METRO Green Line LRT Extension (SWLRT)

Amended Record of Decision

May 15, 2018

FIGURE 1-1: LOCATION OF PROJECT MODIFICATIONS EVALUATED IN THE SUPPLEMENTAL EA

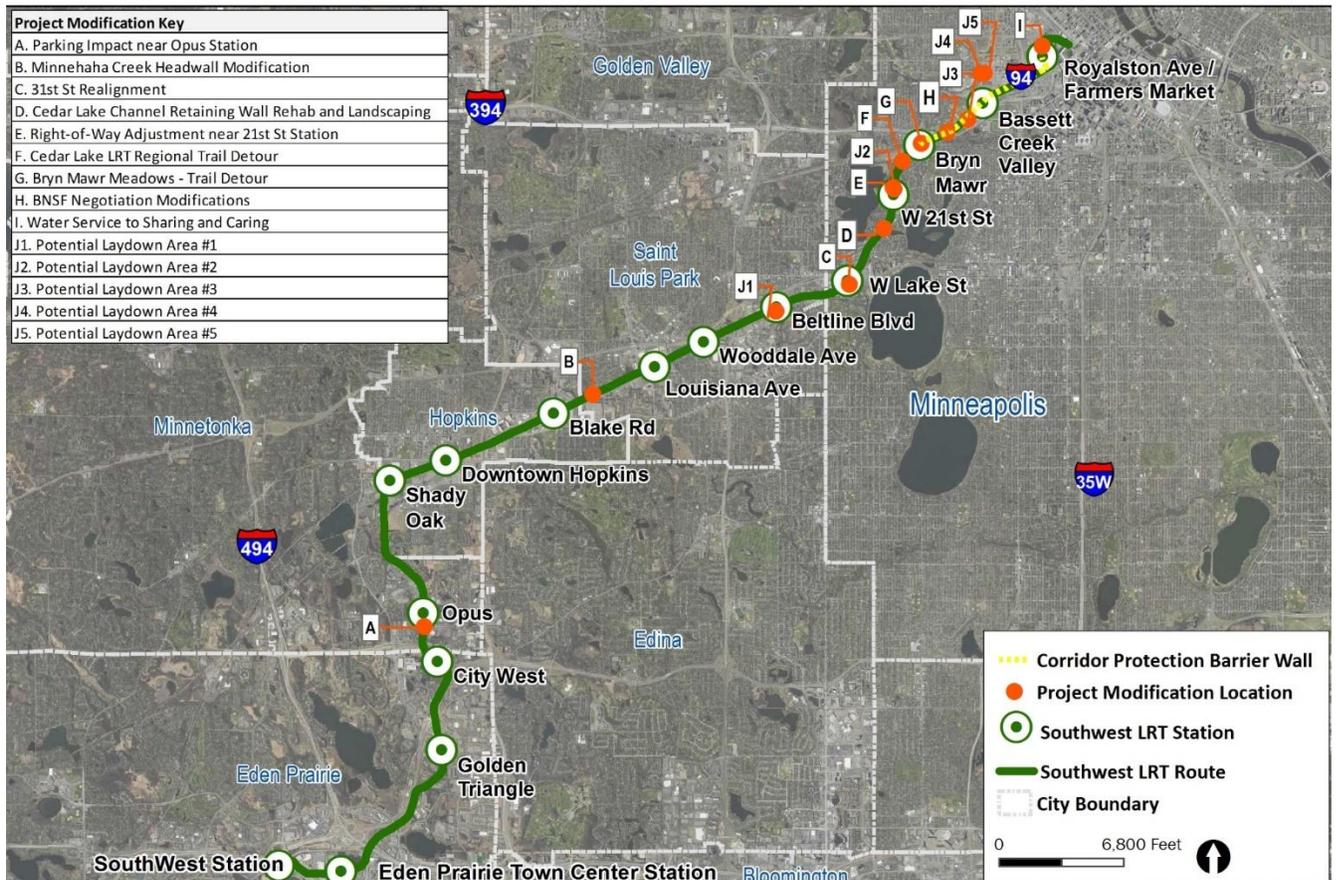
Section 1.3. Project Description. Figure 1-1 uses outdated names for the Bassett Creek Valley and Bryn Mawr stations.
